NOTICE TO CONTRACTORS BIDDING THIS PROJECT

Project Title: Building and Site Improvements at 6741 Downing Avenue, Bakersfield, CA

Contract No: 26016

ADDENDUM No. 5

AD2A

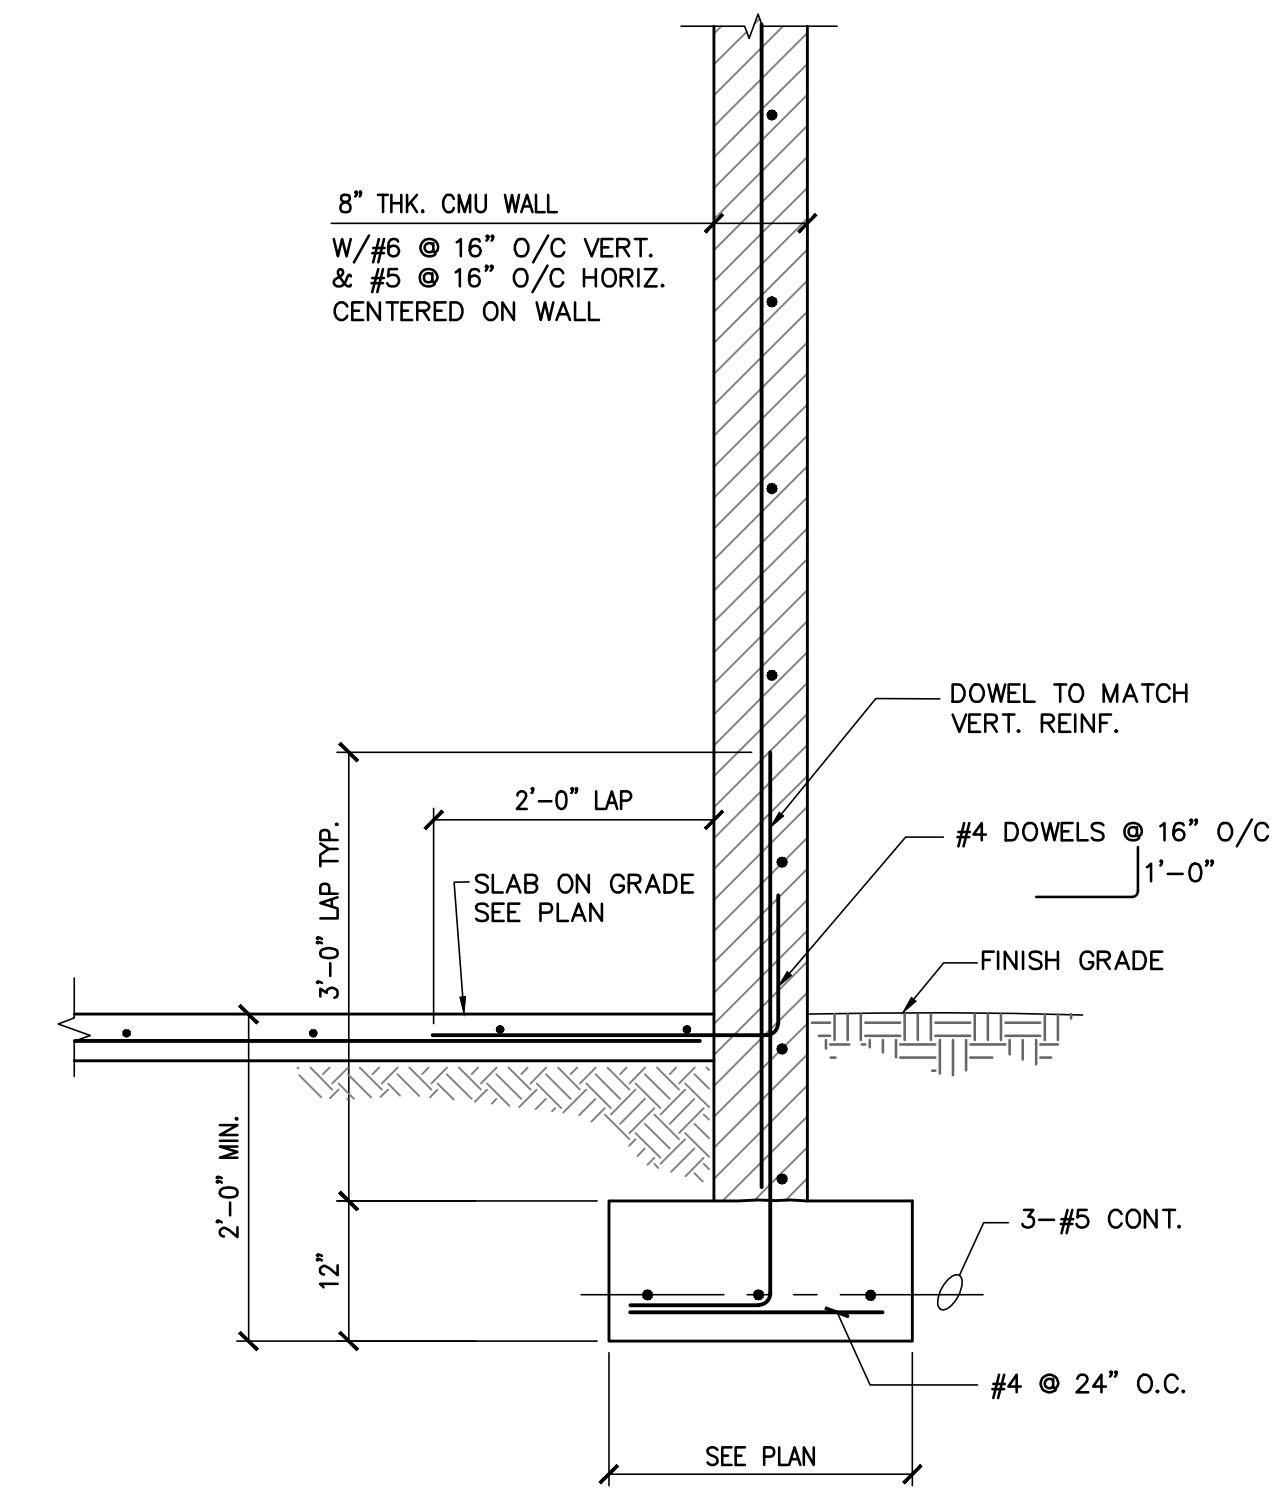
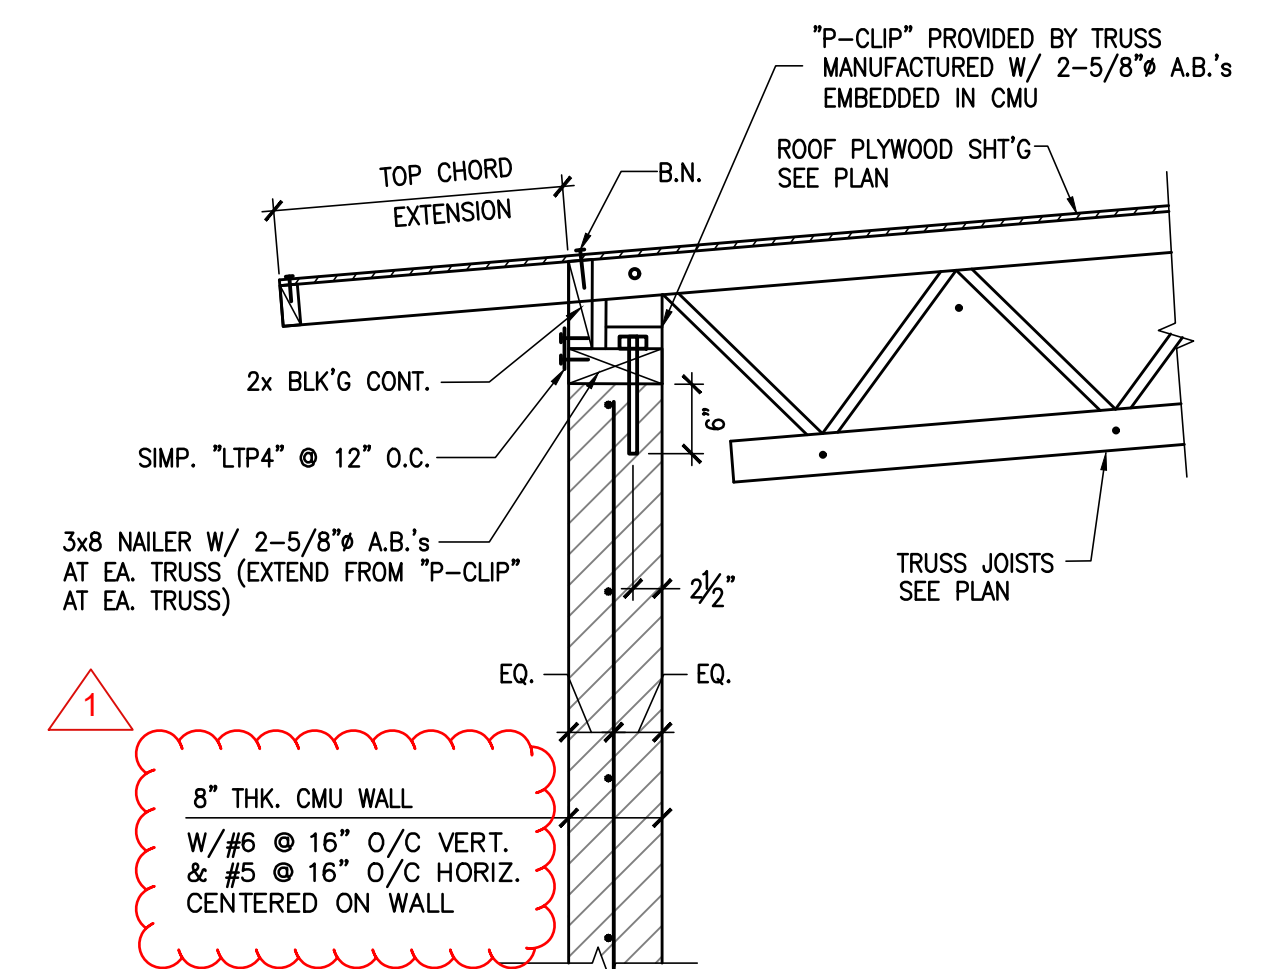
- n. Sheet AD2 has been replaced with sheet AD2A. Detail 28/AD2A has been provided to clarify bike rack requirements. The revised sheet is attached to this addendum.
